LETTER AND U S NAVY RESPONSE TO COMMENTS REGARDING BIOAUGMENTATION
CORRECTIVE ACTION SUBMITTAL PACKAGE NS MAYPORT FL
7/26/1995
ABB ENVIRONMENTAL SERVICES

SUBJECT: Response to Comments on FIFCO International Inc.
Bioaugmentation Corrective Action Submittal Package
NELP Innovative Technology Demonstrations
NAVSTA Mayport
Navy CLEAN District I CTO #0028
Contract No. N62467-89-D-0317

Comments on FIFCO Submittal dated May 1995

FIGURE E-1
TOTAL P.03

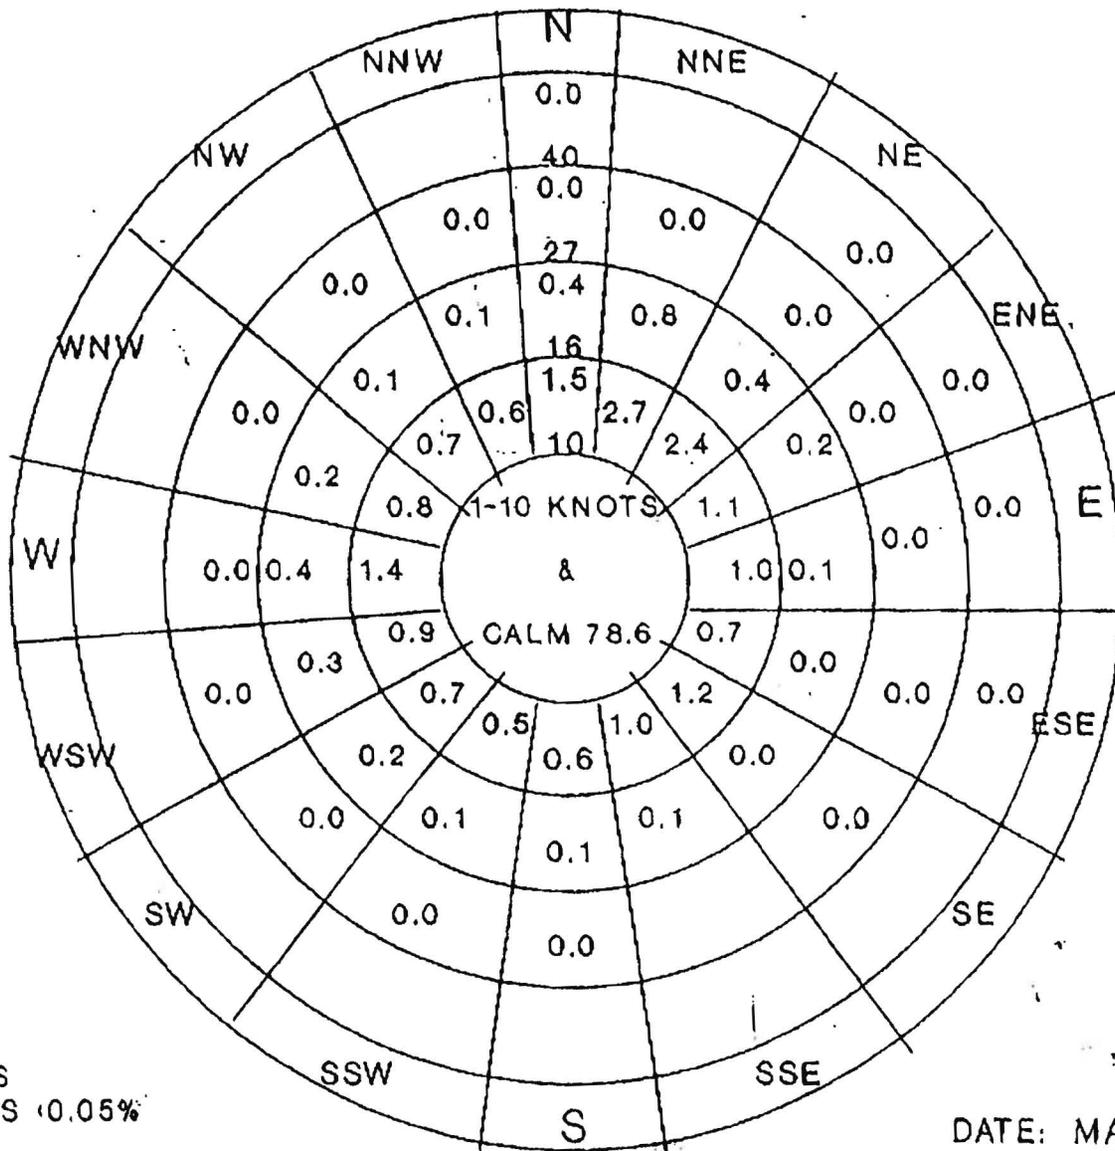
- In the HASP, Section 3.0 (label statements/questions A-I): B - Please insert "This site is a Federally designated Solid Waste Management Unit (SWMU) currently managed under the Station's HSWA permit." D- "There is no known record of injuries at this site. there is no known exposure to chemicals used at this site other than that which would be expected in normal handling and day to day operations. Spills, other than rinsing and dumping of containers, probably occurred at this site during routine operations. There is no record of complaints related to this site." G - "On base housing is located in the southeastern portion of the station. the small town of Mayport is located along the western boundary of the station." I - a wind rose is attached for correct identification of direction and speed. (Mayport)
